CITY PLAN COMMISSION STAFF REPORT

February 7, 2023

Project Name
Atwell Suites Hotel

Request
CD-CPC-2022-00218
Nonresidential Development Plan

DEVELOPMENT PLAN

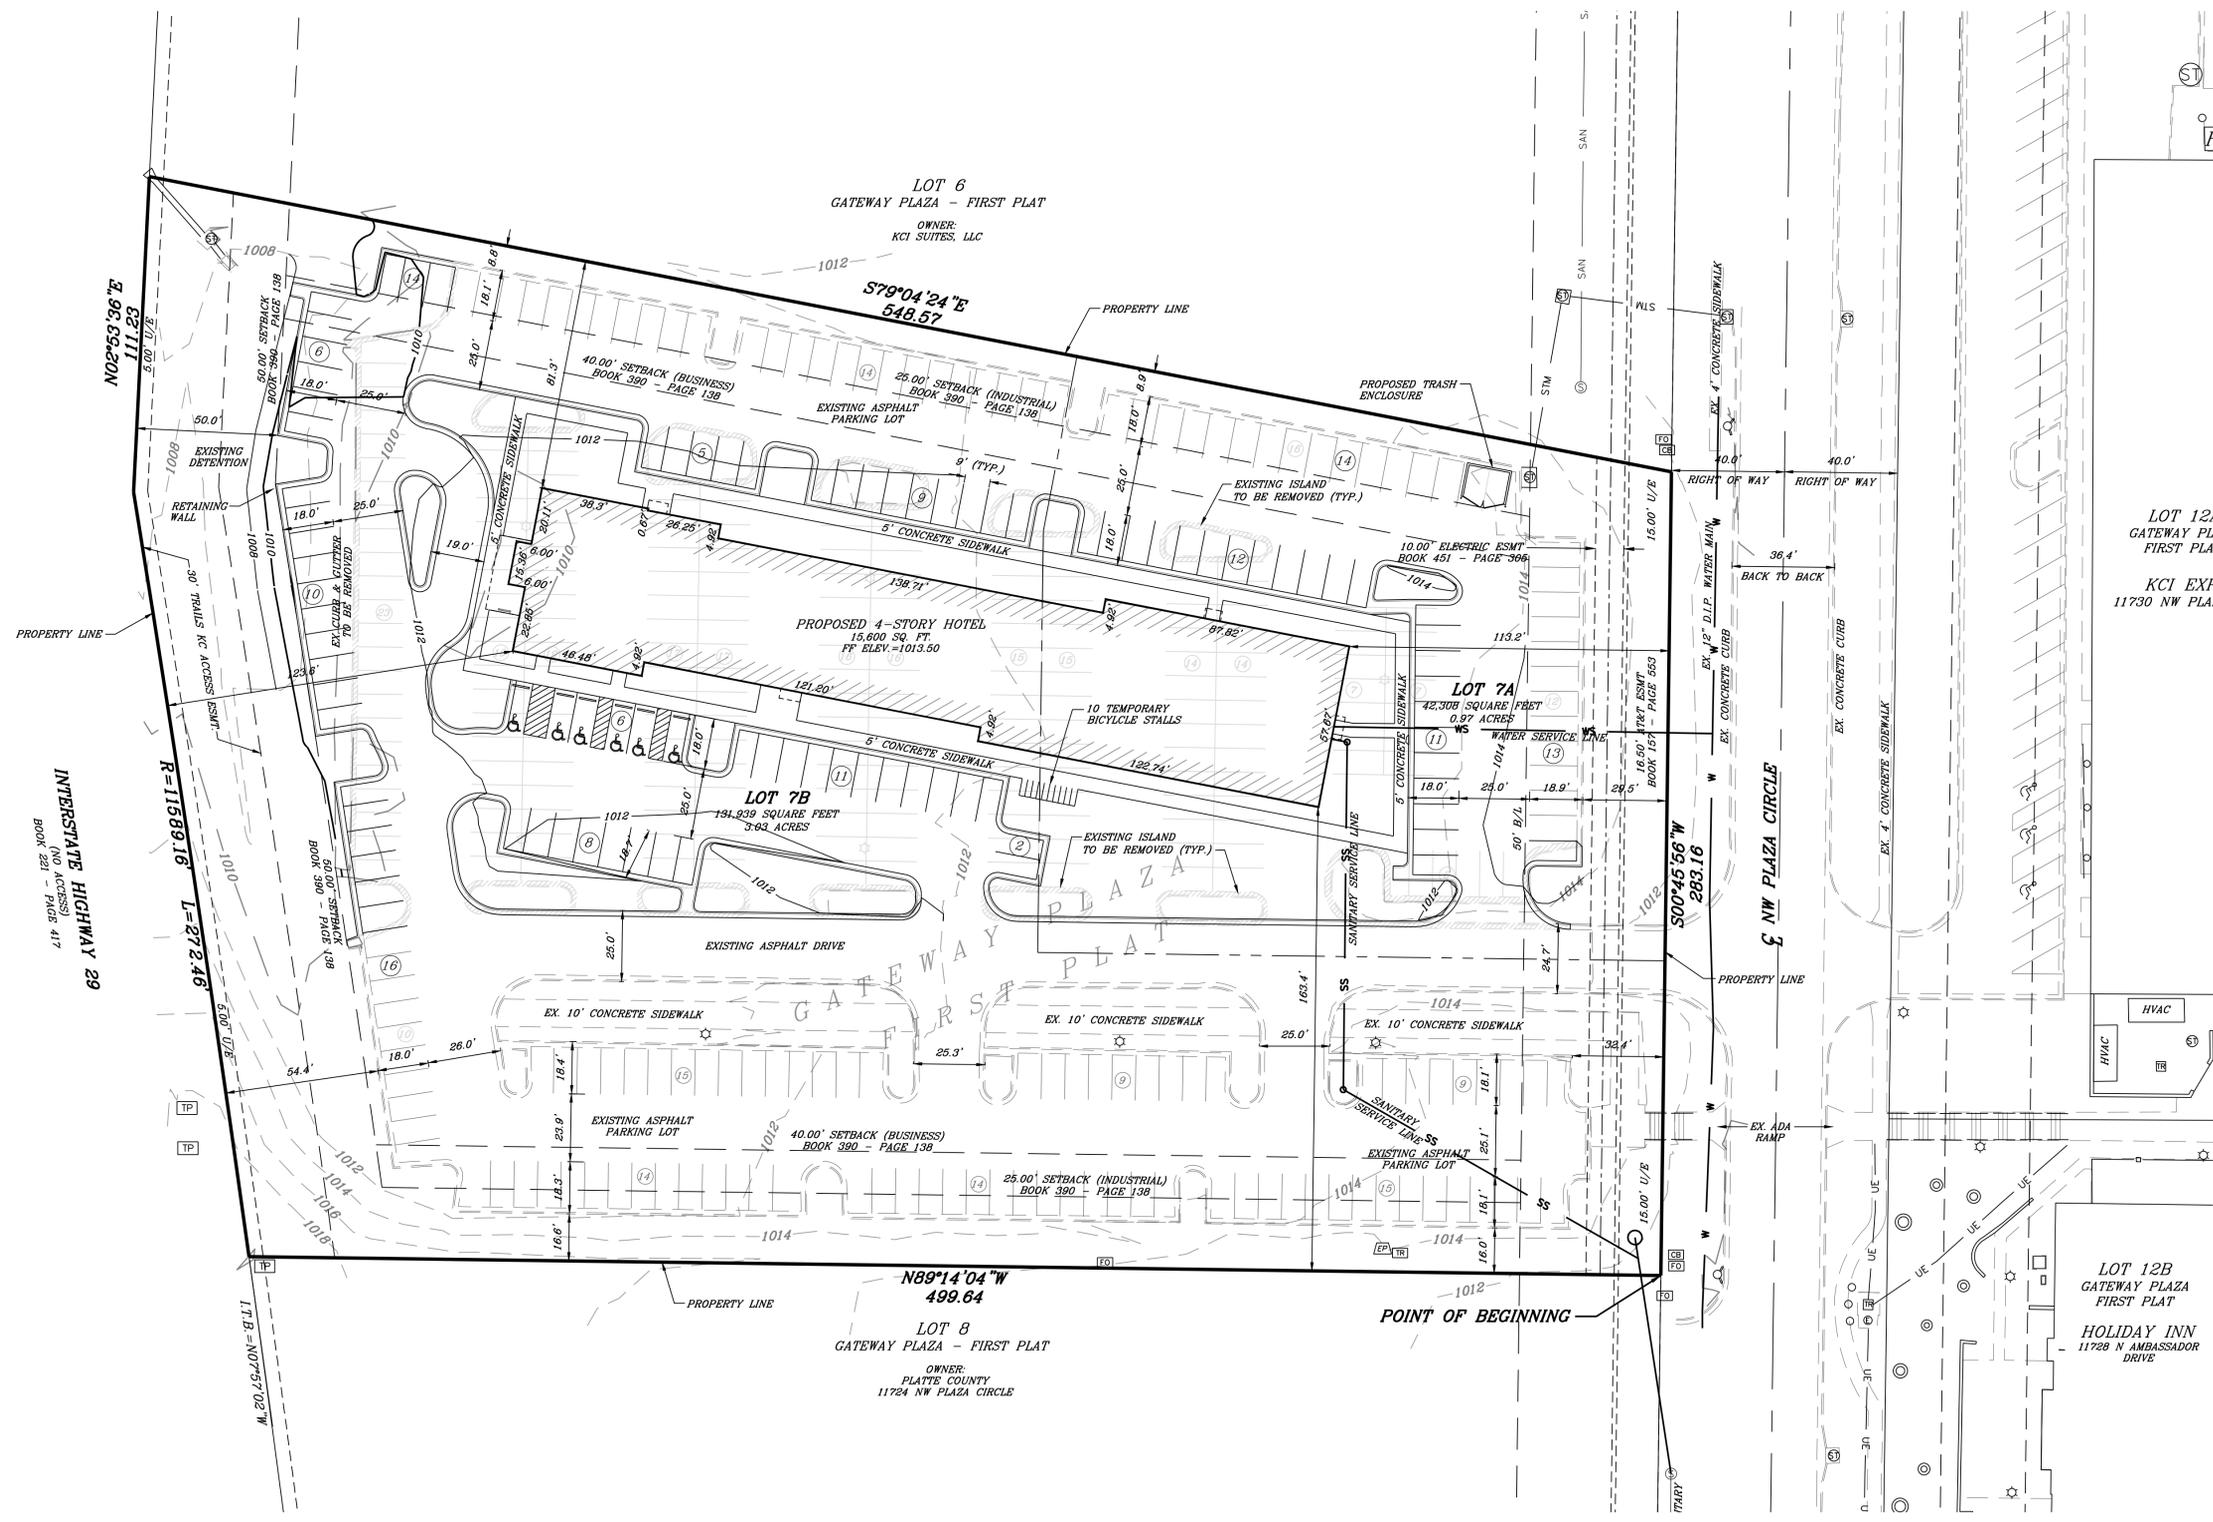
The plan generally complies with all standards of the Code and other City ordinances and policies. Staff has requested that the developer submit a revised plan prior to ordinance request to ensure that the interior landscaping of the parking area complies with 88-425-06. The developer shall also provide revised building elevations that reduce the amount of EIFS currently proposed prior to ordinance request.

The proposed landscape plan generally complies with the Zoning and Development Code. The developer will be required to submit revised plans to illustrate that the southern parking area is in compliance with City Code.

The developer is providing a total of 227 parking stalls which far exceeds what is required. Staff understands that the hotel may host events where all the parking may be necessary.

8. All vehicular use areas shall comply with 88-425-06 and a revised landscape plan shall be submitted to DMD prior to ordinance request.
9. The developer shall submit revised building elevations showing a reduction in the current proposed amount of EIFS prior to ordinance request.
